Appendix C. Flow Budget, In-Flow Schematic and Out-Flow Schematic Lower Payette River, 1996

LOWER PAYETTE RIVER TMDL PROJECT Historic BOR-USGS Monitoring Sites

Major Diversion Sites on the Lower Payette River Diagram is not to scale, and should be used only as reference to river locations.

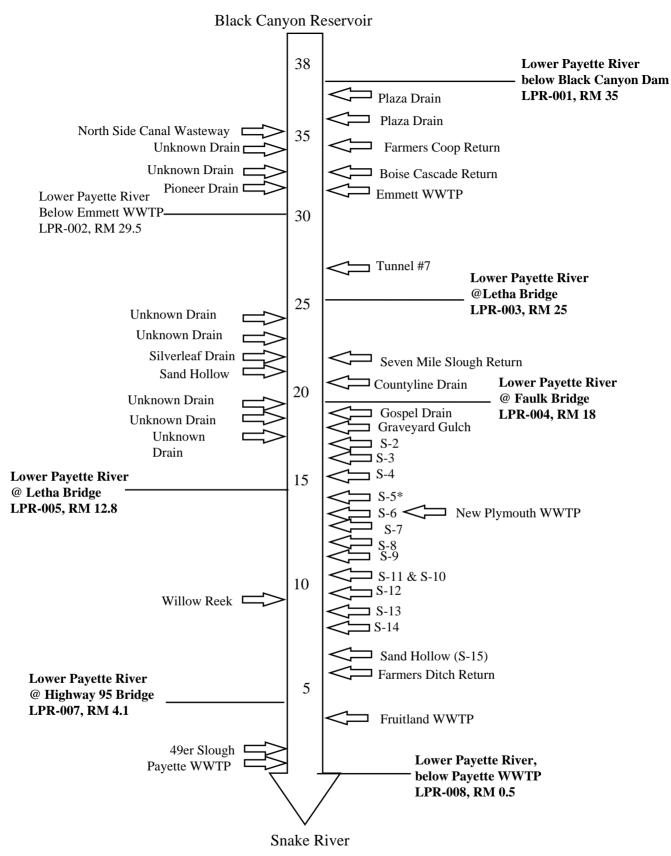
Response: Misspelling of Noble Canal is noted, and will be changed. A reference to the Enterprise and Bilbrey Canals are noted in the mass-balance spreadsheets, but will be added to the schematic. Letah ditch can not be located in the Water master's Report, Payette Water District #65. Many of the Ditches and Canals may originate from the 7 Mile Slough. It is difficult to determine which ditch is Letha Ditch, or if it originates from the Payette River or from the 7 Mile Slough. A map location and a average cfs withdrawal would be helpful in showing this ditches origin. Not all ditches, canals, and pumps are shown (too numerous). The schematic and the mass-balance limited withdrawals to 20 cfs or greater.
